## DEVIATION REQUEST AND DECISION FORM

Project Name : Latigo Filing 10

A deviation from the standards of or in Section **ECM section 3.3.7 Permanent Storm Water Management Facilities** of the Engineering Criteria Manual (ECM) is requested for the proposed Temporary "Full Infiltration Treatment Control Pond".

PCD File No. SF-21-037

EXHIBIT A

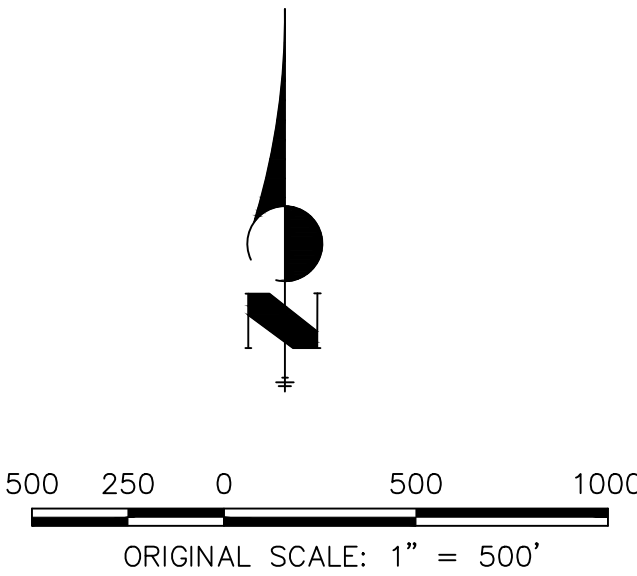
Update paragraph to make it clear the "interim" infiltration pond will be removed and replaced by the ultimate pond (EDB) with Filing 11.

Revise statement to infiltrate at least 99% of the runoff within 120 hours after the end of the 100yr event.

Added more explanation

Added
